7 September 2023

Response to the Mt Munro Proposed Wind Farm Resource Consent Application Section 92 Additional Information Request

The information included in this letter and its appendices are provided in response to your 6 July 2023 request for further information (RFI).

CLIENT	MERIDIAN ENERGY
PROJECT	MT MUNRO - MEL WAIRARAPA WIND FARM
TITLE	OLD COACH ROAD SHEET 2
SCALE (A3)	1:500
DWG No.	1016884.1000-101
REV	1

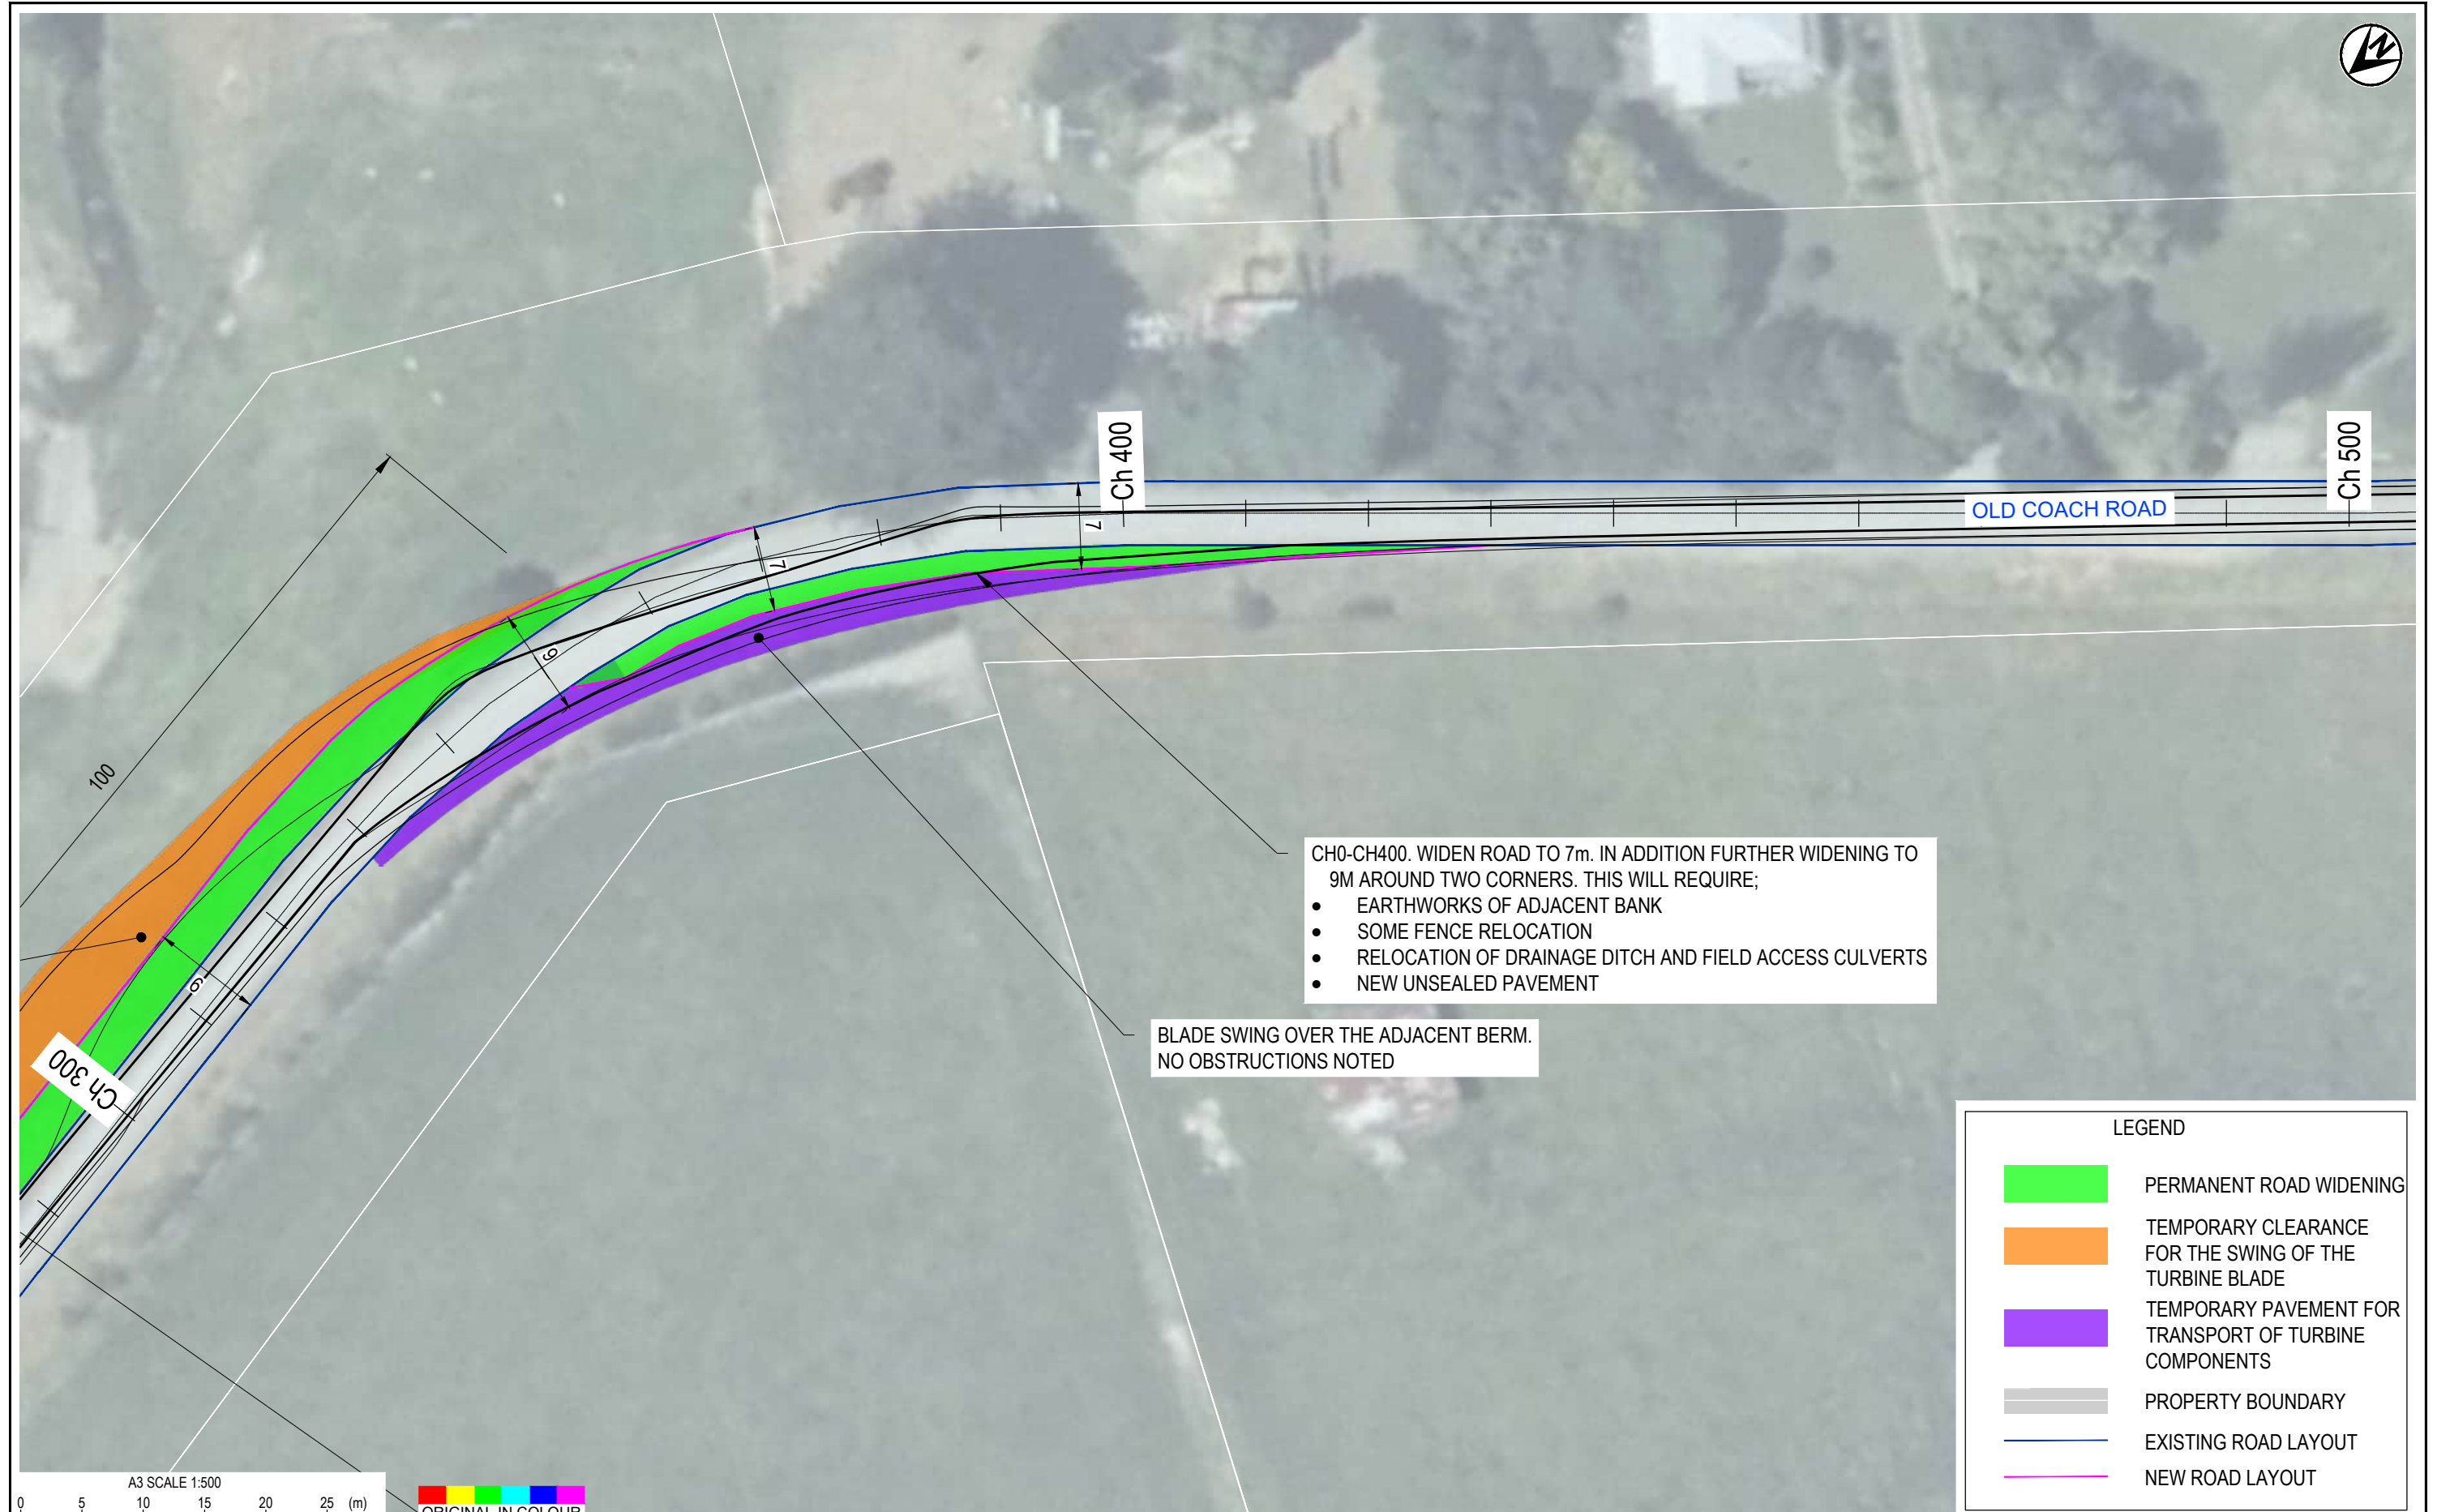
CH0-CH400. WIDEN ROAD TO 7m. IN ADDITION FURTHER WIDENING TO 9M AROUND TWO CORNERS. THIS WILL REQUIRE;

CLIENT	MERIDIAN ENERGY		
PROJECT	MT MUNRO - MEL WAIRARAPA WIND FARM		
TITLE	OLD COACH ROAD SHEET 4		
SCALE (A3)	1:500	DWG No.	1016884.1000-103
REV	1

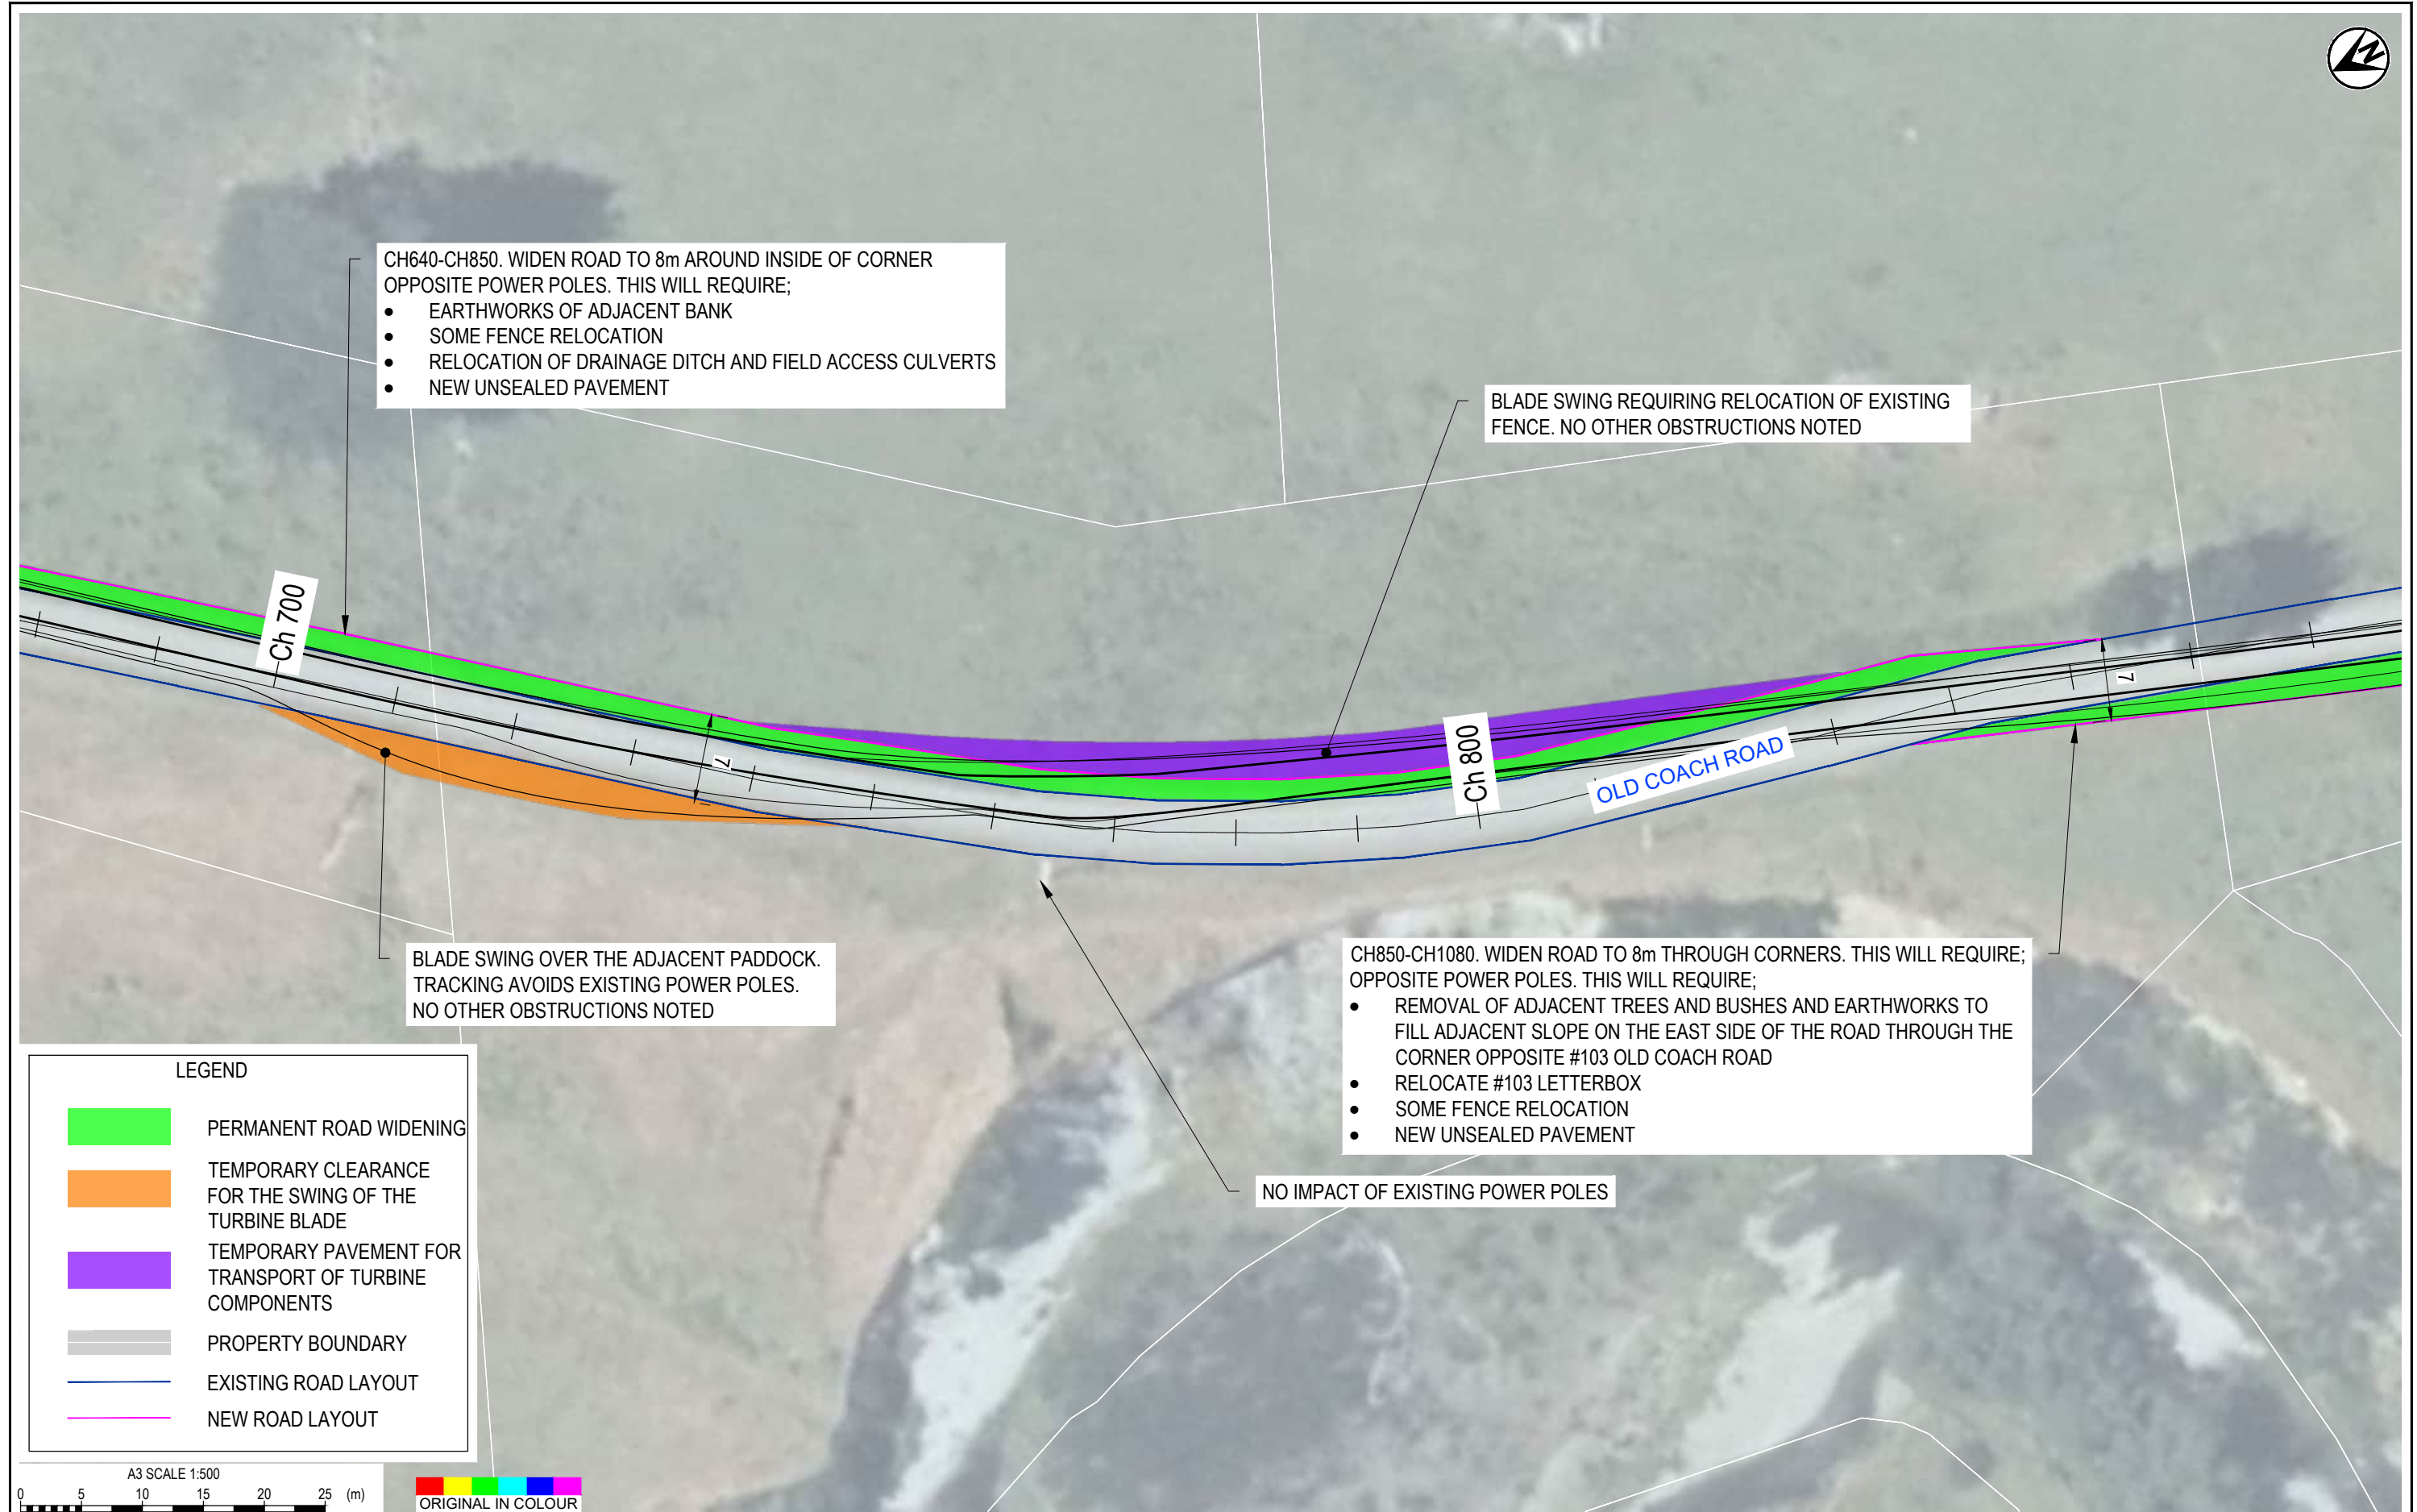
CH640-CH850. WIDEN ROAD TO 8m AROUND INSIDE OF CORNER OPPOSITE POWER POLES. THIS WILL REQUIRE;

CLIENT	MERIDIAN ENERGY
PROJECT	MT MUNRO - MEL WAIRARAPA WIND FARM
TITLE	OLD COACH ROAD SHEET 6
SCALE (A3)	1:500
DWG No.	1016884.1000-105
REV	1

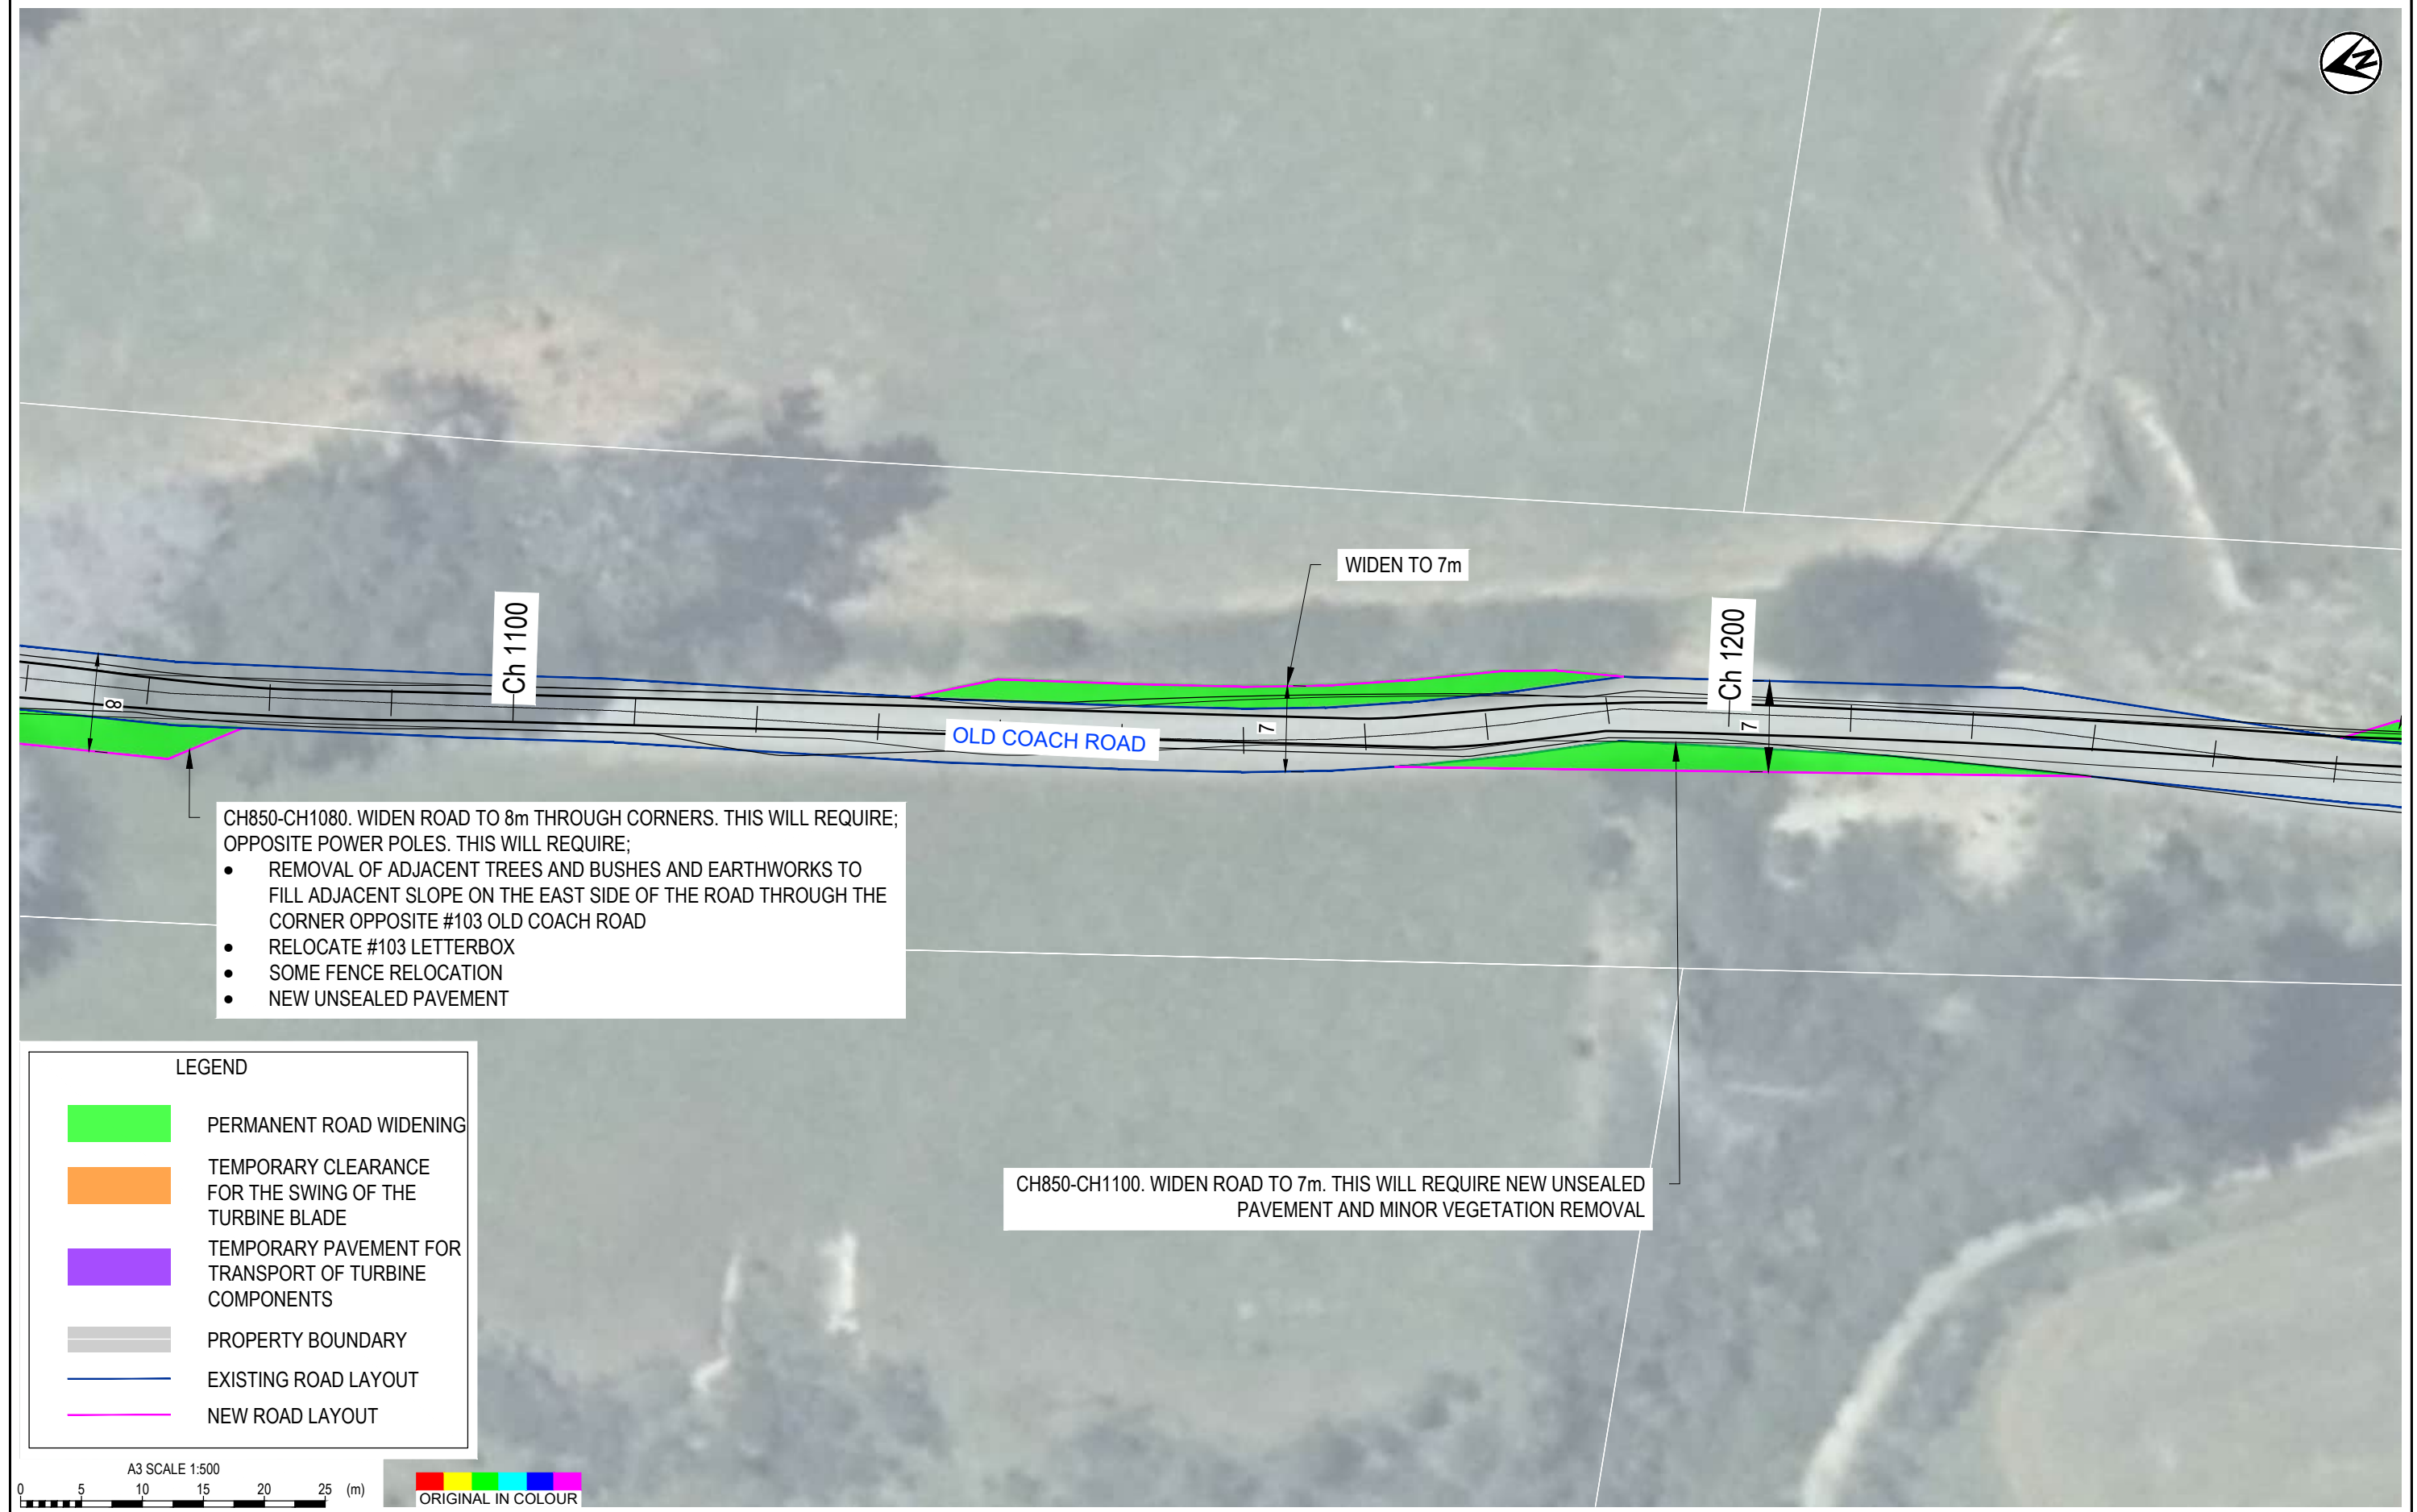
CH850-CH1080. WIDEN ROAD TO 8m THROUGH CORNERS. THIS WILL REQUIRE; OPPOSITE POWER POLES. THIS WILL REQUIRE;
